PENNSYLVANIA
FOUR-MILE RUN DAM

NDS I.D. No. PA - 00457
PENNDER I.D. No. 65 - 126

PHASE I INSPECTION REPORT
NATIONAL DAM INSPECTION PROGRAM

AUGUST 1979

FIGURE 1 - FOUR MILE RUN DAM
 GENERAL PLAN : FIELD INSPECTION NOTES

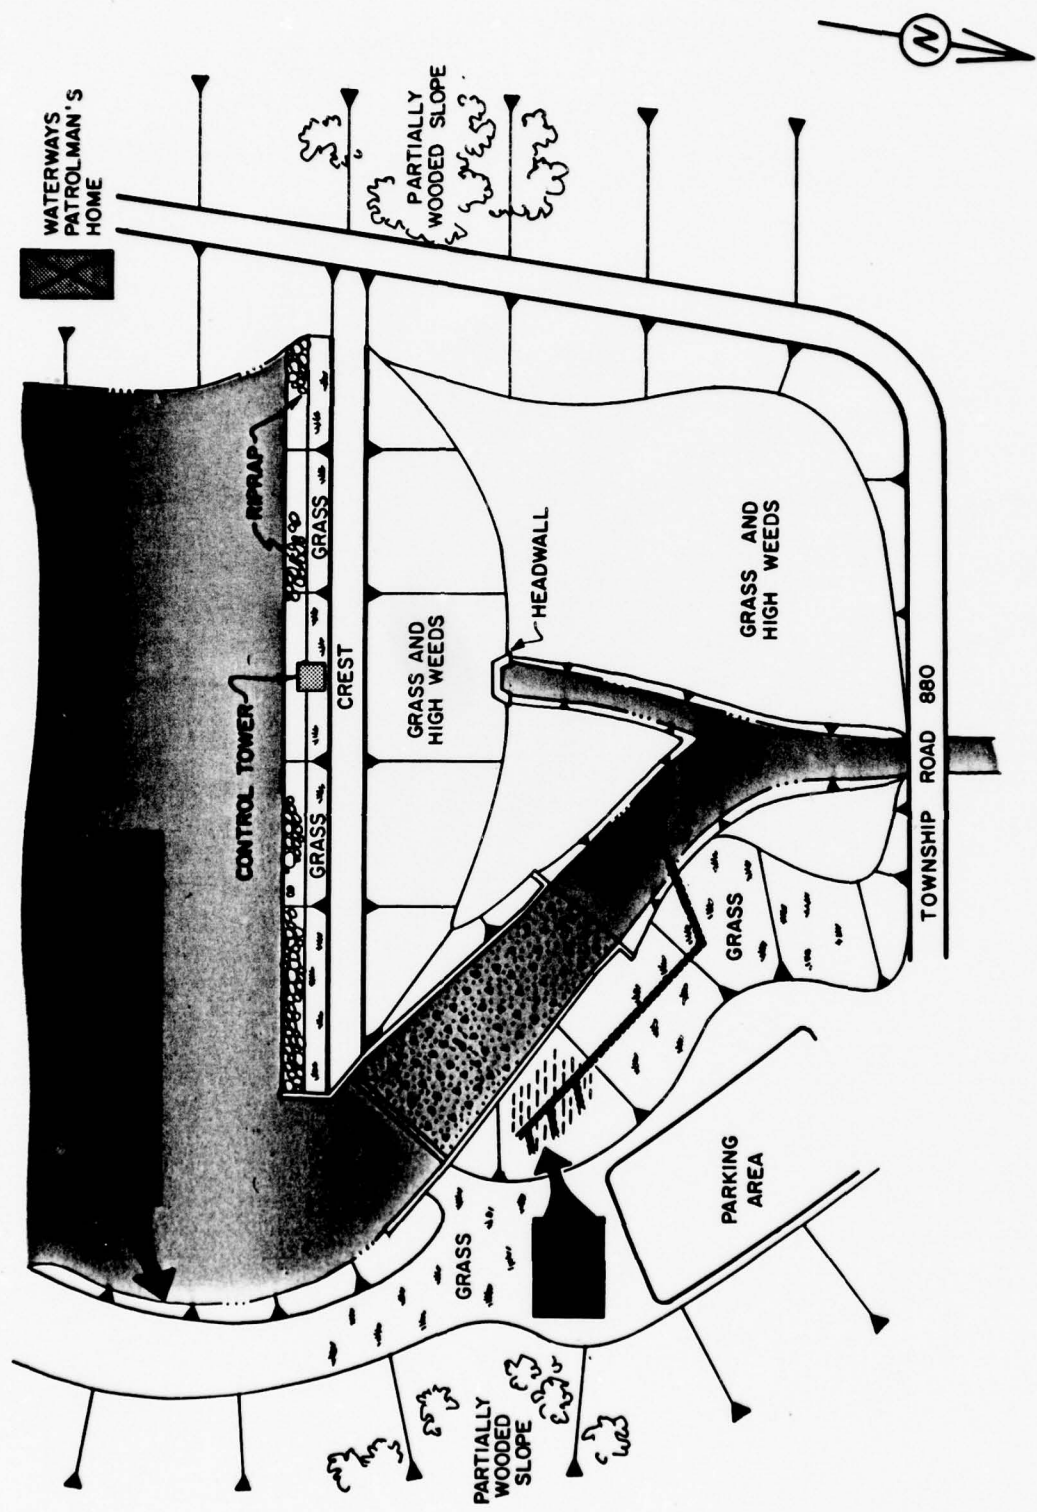
b. Embankment. Observations made during the visual inspection indicate the embankment is in good condition. Minor seepage was noted along the embankment toe about 15 feet to the right of the spillway. The wet area created by the seepage is 25 feet wide and roughly confined to a narrow strip 3 to 8 feet below normal pool. The area is drained by a 4-inch diameter perforated PVC pipe laid in a trench and covered with crushed stone that discharges below the spillway plunge pool. Otherwise, no evidence of sloughing, erosion, animal burrows, or general maintenance neglect were observed.

1. Spillway. The visual inspection revealed the spillway is in good condition. Several minor cracks were observed along the concrete wingwalls which were filled and sealed with epoxy. The approach channel sidewall at the right abutment is not adequately protected with riprap and is subject to erosion.

2. Outlet Works. The outlet works are in good condition. The 4-foot square box culvert was entered and several diagonal cracks were observed in the culvert walls in the segment located about 10 to 20 feet from the control tower riser. No signs of concrete deterioration were observed on the interior or exterior surfaces of the control tower riser. The stop logs were in place and performing as designed.

a. Immediately fill and seal all cracks within the interior of the outlet conduit.

b. Specifically address the seepage condition observed to the right of the spillway in all future inspections and note any turbidity or changes in the rate of flow.

1. Include a definite procedure of notifying downstream residents of a possible emergency.
2. Provide for an alternate means of communication in the event telephone lines become inoperative.
3. Provide for around-the-clock surveillance of the facility during periods of unusually heavy precipitation.
- d. Provide additional riprap protection along the right sidewall of the spillway approach channel.
